SERVICE LETTER**NUMBER:** SL-008**DATE:** 05/22/09**SUBJECT:** Instructions for Aircraft Field Modification of Cabin Light Time Delay Relay**SUMMARY**

SL-008 Instructions for Aircraft Field Modification
of Cabin Light Time Delay Relay

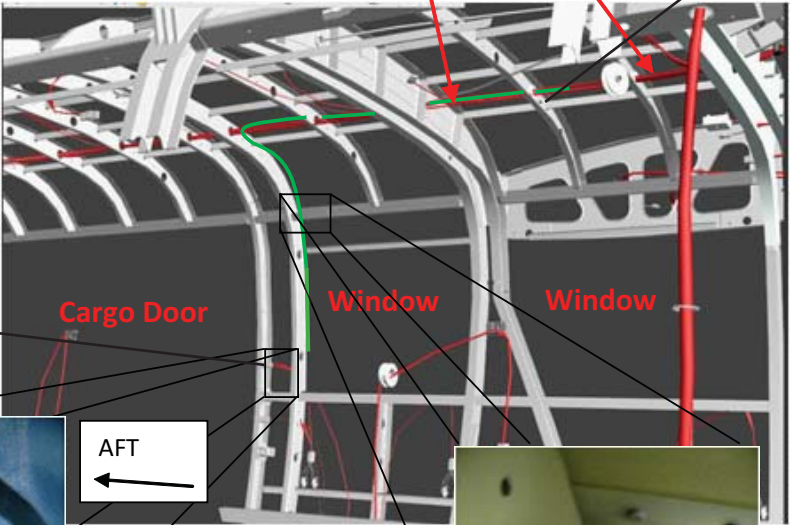
The KODIAK 100 is equipped with a time delay relay that will automatically illuminate the cabin lights for a period of 30 minutes when the entry ceiling light rocker switch near the cargo door is pressed. Power for this function is taken directly from the aircraft battery to allow its use even when the master switch is "OFF". The time delay relay has a small amount of current drain and may excessively discharge the battery during longer periods of aircraft storage. This modification prevents battery drain during storage when the cargo door is closed.

To prevent potential discharge of the battery, follow the instructions provided in this Service Letter for the field retrofit/rewire of the KODIAK 100.

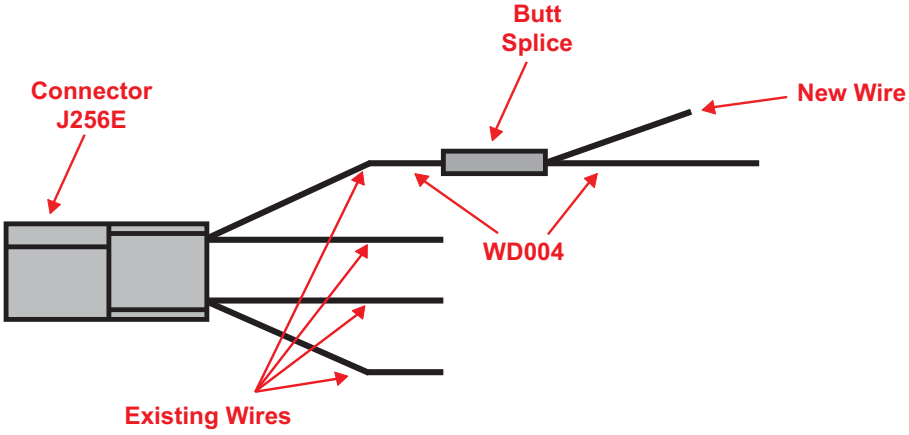
Task	Instruction	Visual
1	Gather materials: 8-ft 22 AWG wire (P/N MS22759/16-22-9) 2x wire splice (P/N AMP D-436-37)	
2	Remove PSU Duct (if installed) in accordance with the KODIAK 100 Maintenance Manual . Remove left interior window panel in accordance with the KODIAK 100 Maintenance Manual . NOTE: Use a scribe to pry cap mouldings out of track working forward to aft.

Task	Instruction	Visual
3	Remove forward and mid cabin ceiling panels as necessary to access wire bundle.	
4	Remove the nut from the ground stud in L/H ceiling between spar carrythroughs.	
5	Remove the wire labeled LC012 from ground stud and cut ring terminal from wire. (One of the white wires in the above picture is labeled LC012.)
